## PLANNING COMMISSION MEETING

**RE: Comfort Care Assisted Living- Preliminary Site Plan Review – 2<sup>nd</sup> Review**

**RE:** Comfort Care  
Rezoning and Preliminary Site Plan – Review #2

DRAWING TITLE  
**SITE LAYOUT PLAN**

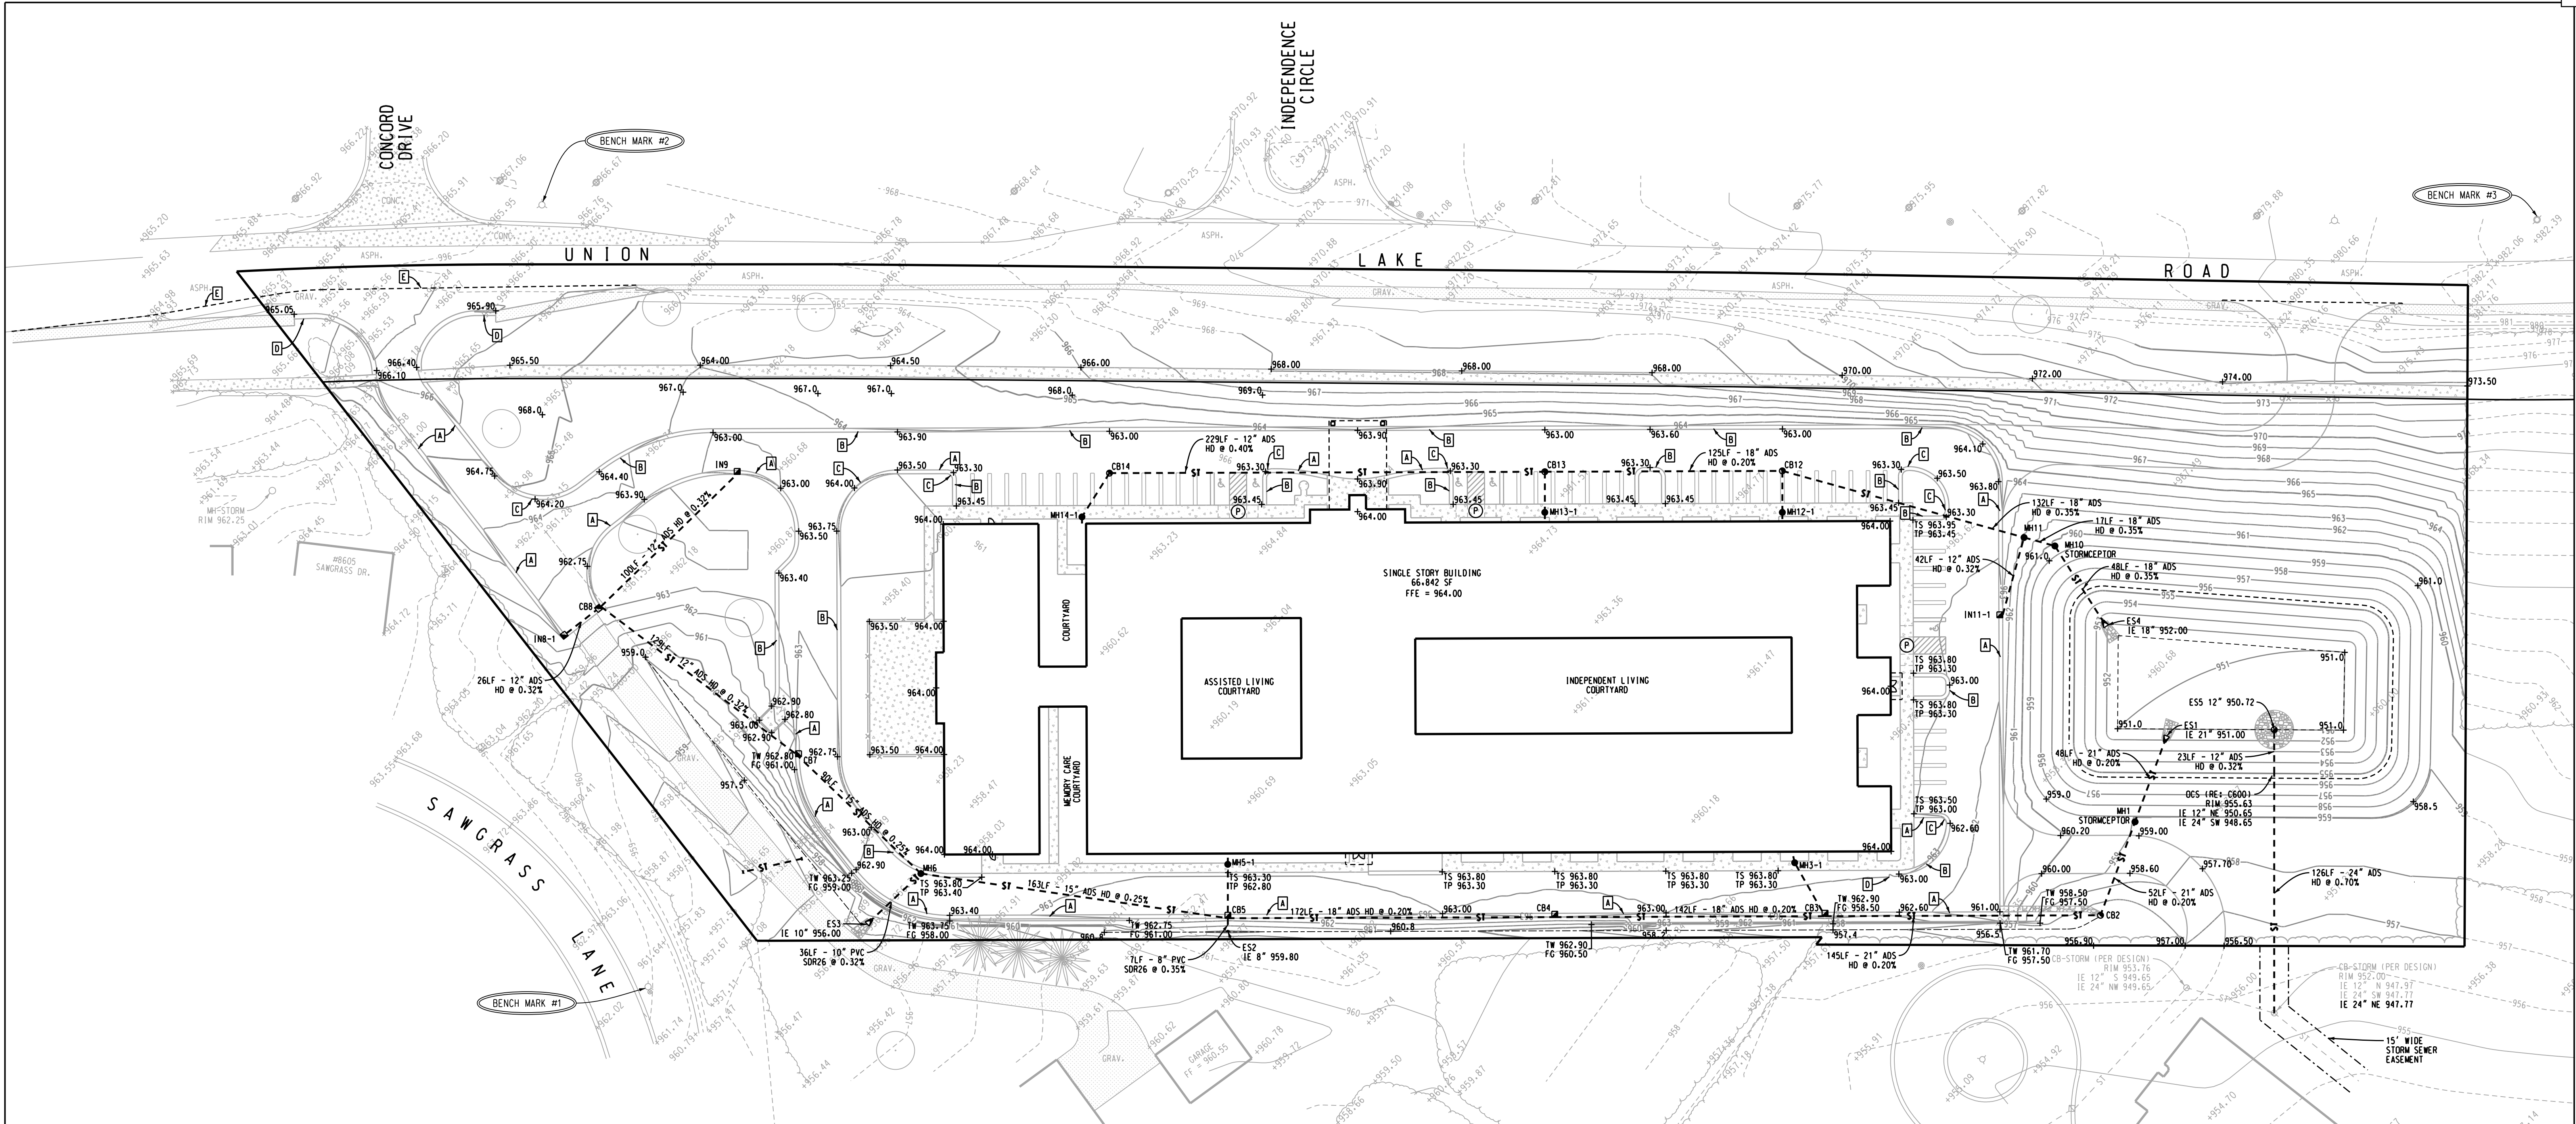
- d) *It is not clear as to whether the western drive proposed behind the building is proposed as a one way or two-way drive. It is currently proposed as 22' wide. Township Zoning Ordinance 5.11Q.v. requires a width of 20' for one way drives and a minimum width of 24' for two way drives. Comment addressed. Drive is now shown as 24' wide.*

- e) *The sidewalk along Union Lake Road is proposed at 5' wide. Township Zoning Ordinance 5.21 requires a minimum of 6' width for sidewalks along major roadways. Comment addressed. Sidewalk is now proposed as 6' wide.*

DRAWING TITLE  
**SITE UTILITY PLAN**

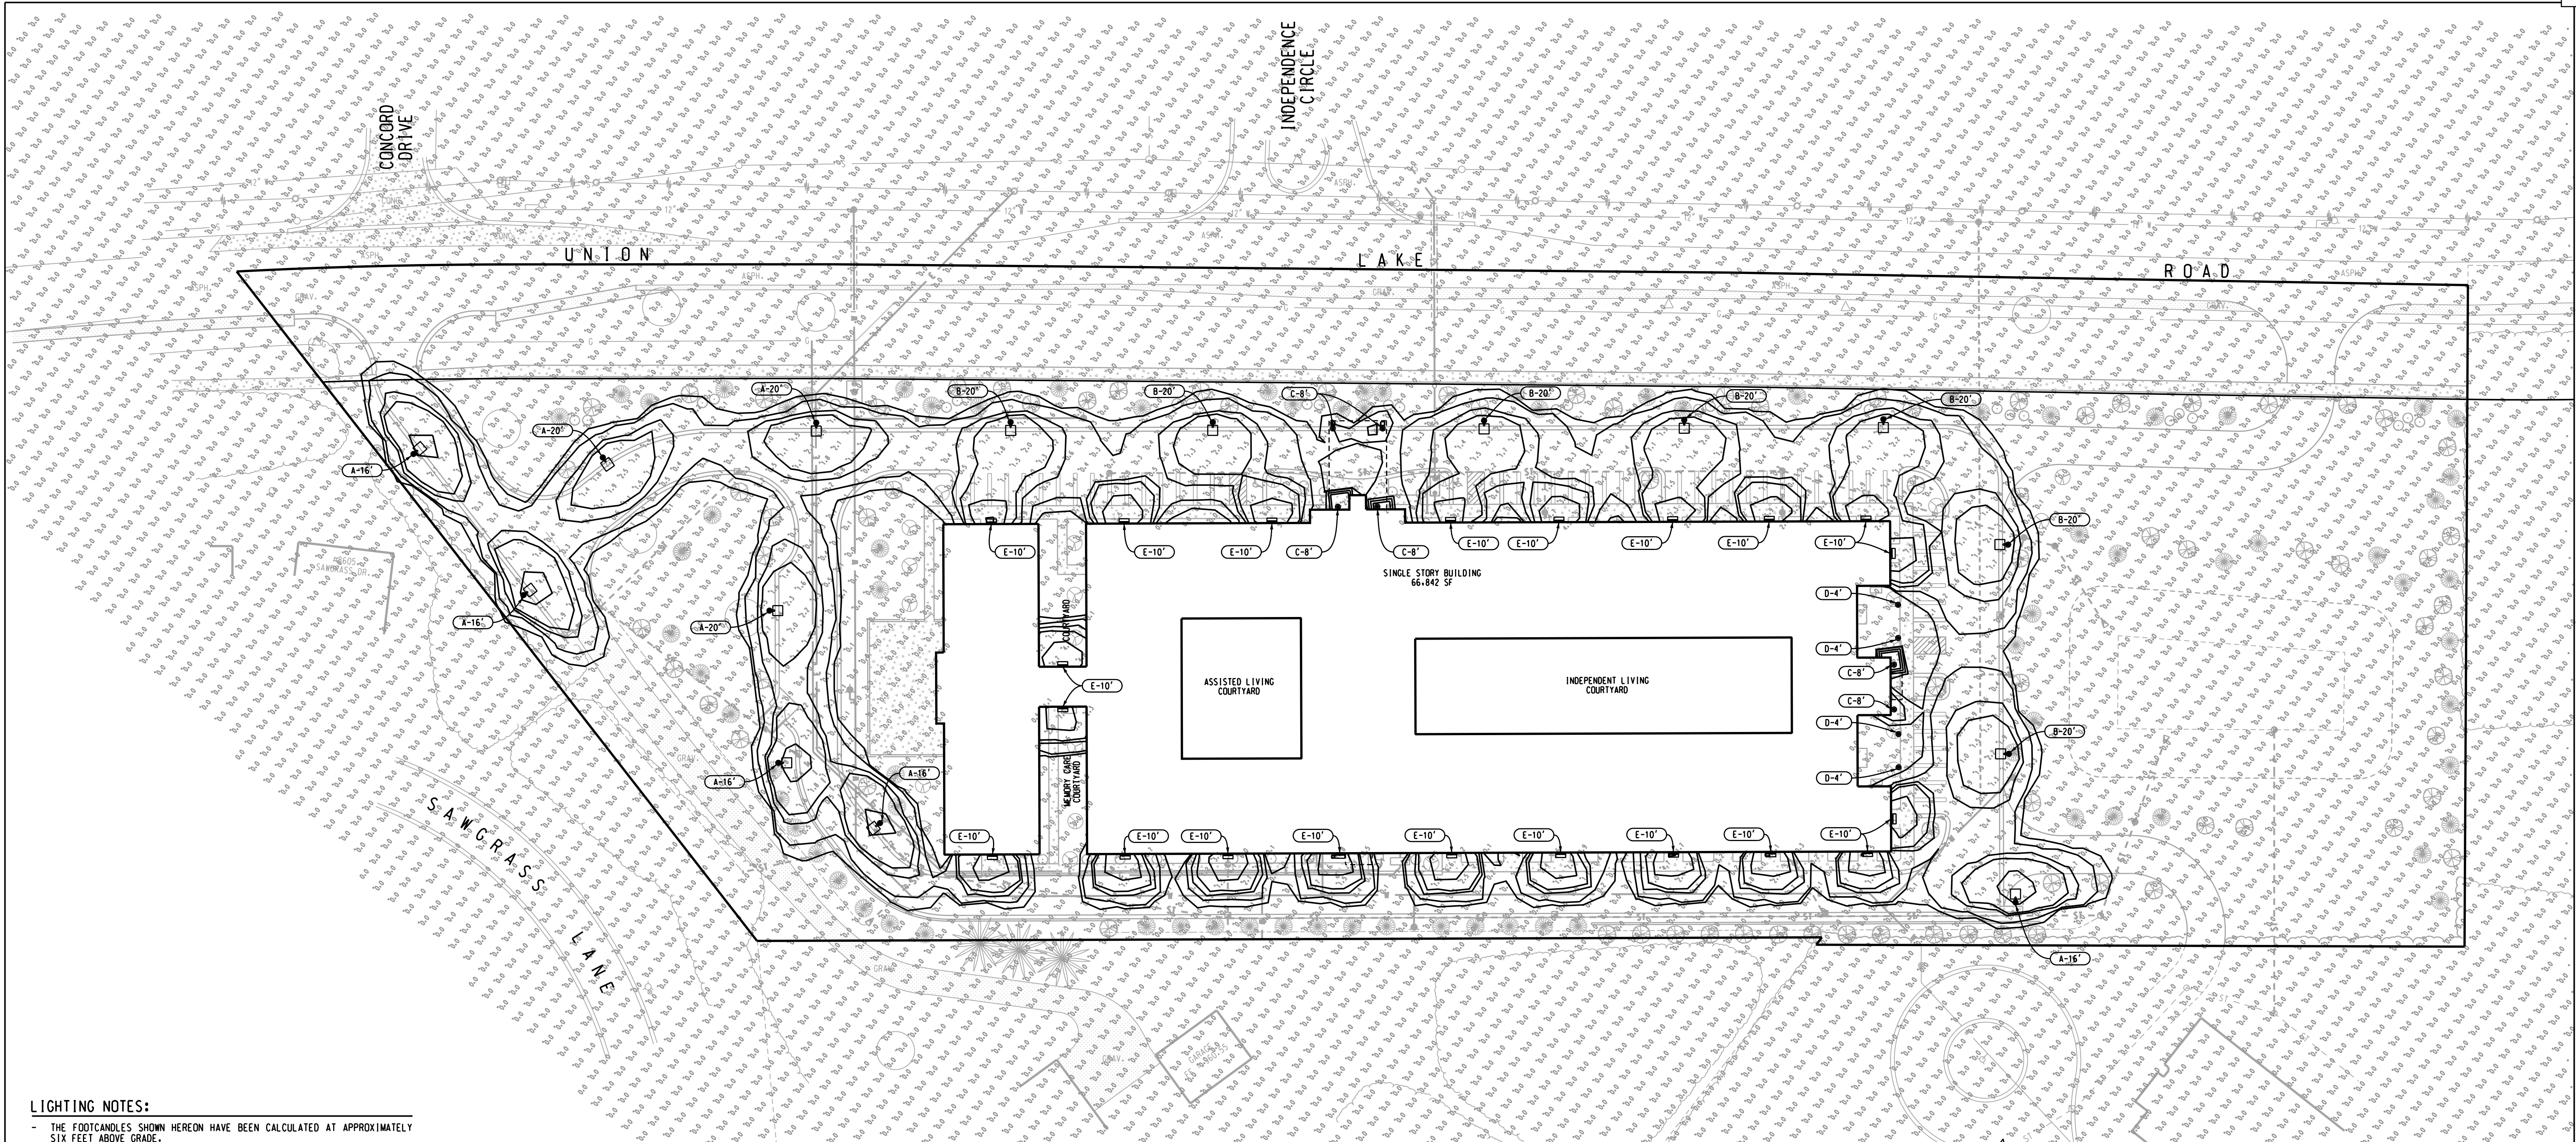
1. We defer to the Fire Department regarding items related to fire suppression and hydrant coverage. **Comment remains as a notation.**
2. Remove all references to Genesee County on the water main notes on Sheet C400- Site Utility Plan. Note that all notes regarding proposed utilities shall be per White Lake Township standards. **Comment outstanding.**
3. Hydrant leads exceeding 40' must be 8" diameter piping. **Comment addressed.**

DRAWING TITLE  
**SITE PHOTOMETRIC PLAN**

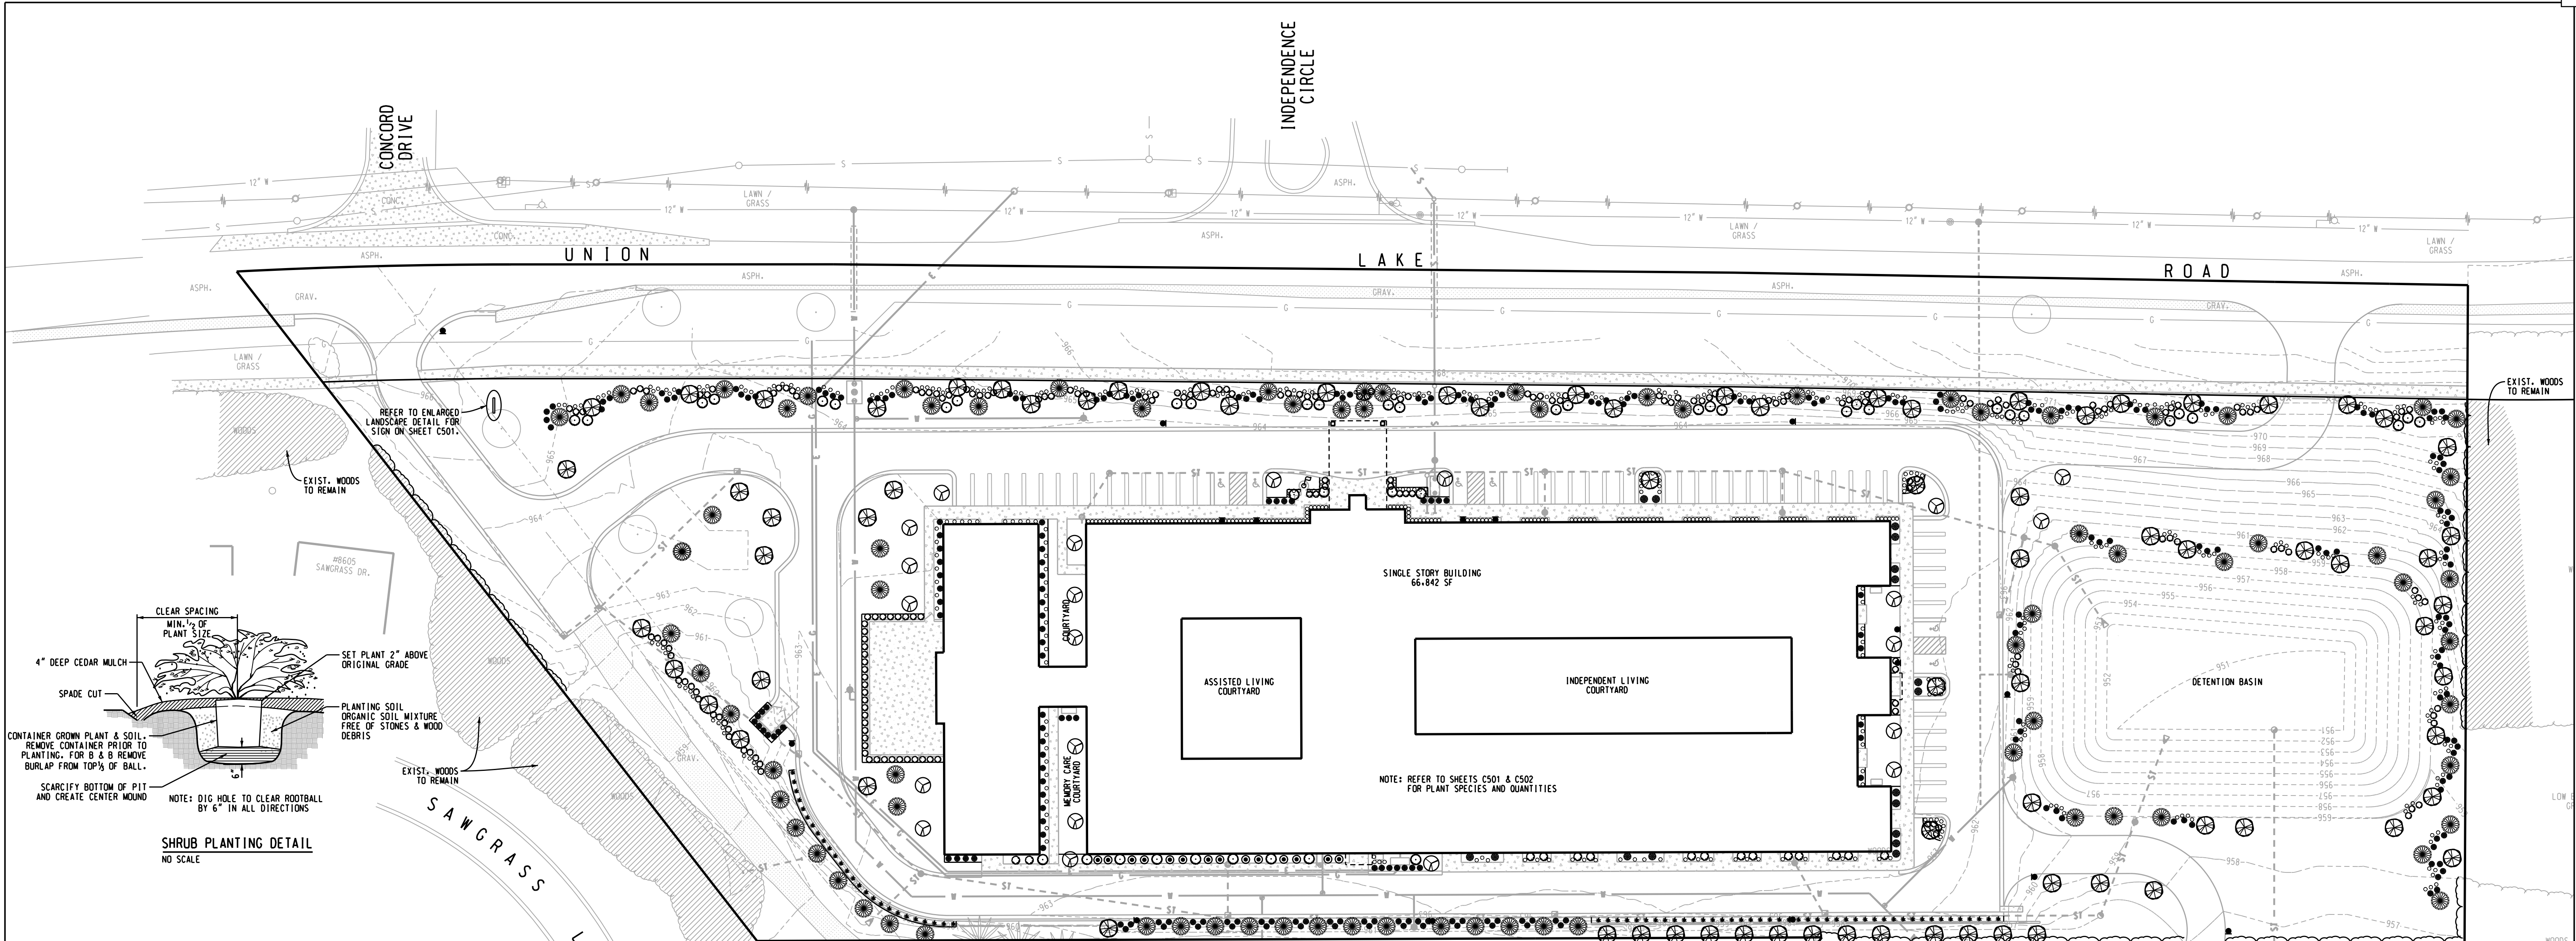
- Outdoor lights must meet the performance standards of Article 5, Section 18.G of the zoning ordinance.
- Footcandles shall be measured at approximately six feet above grade. **Revise accordingly, and the plan must contain a note confirming footcandles are measured at six feet above grade.** (Comment addressed. A note has been added to Sheet C401 indicating footcandles have been calculated at approximately six feet above grade).
